NUMBER: B402R1110-0

## SERVICE BULLETIN

Ride: WIPEOUT

Subject: Electrical Overload Protector  
Inspection/Replacement

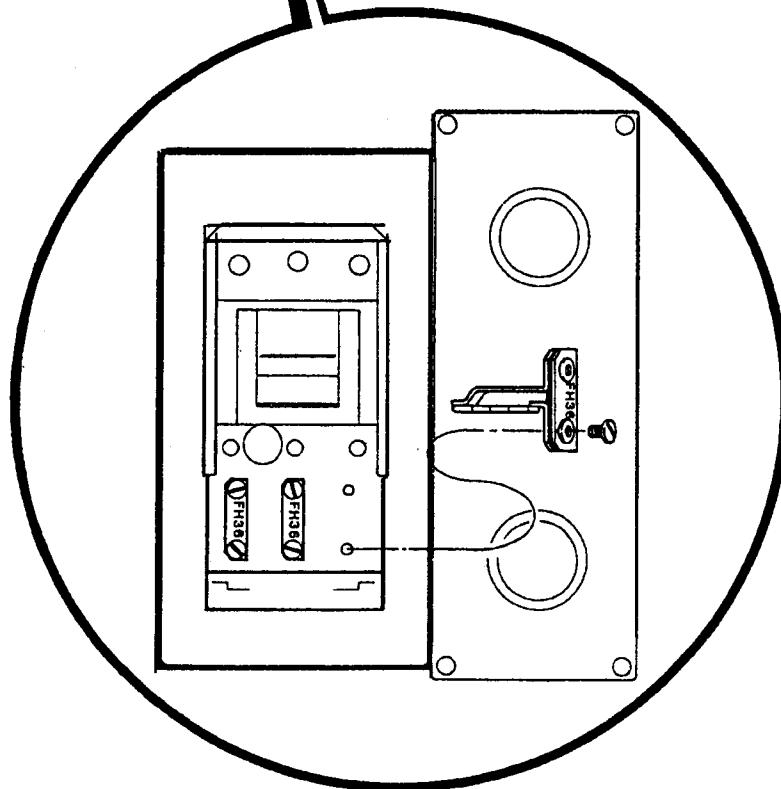
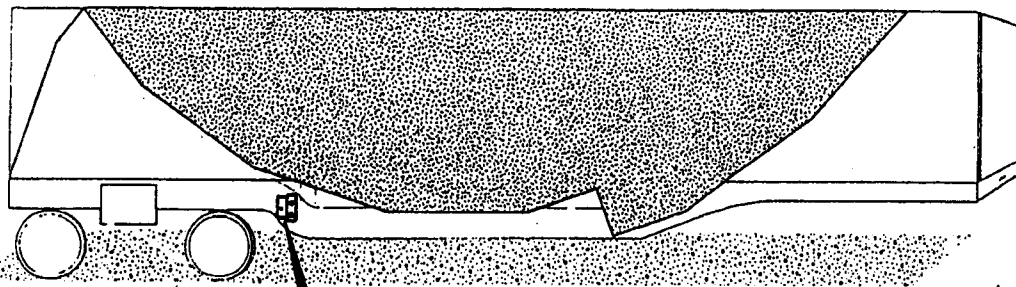
Three heaters are located in box between rear leveling jack and the floor/jack receptacle box, located on the curbside of the trailer.

1. Remove cover from box by removing the one screw located at the bottom of the box.
2. Heaters are labeled as to size. Correct size is FH36. If any other size heater is present, order and install new heaters, part number 23324700.
3. To replace heaters, remove the two (2) screws securing the heater in place.
4. Reinstall cover after work is completed.
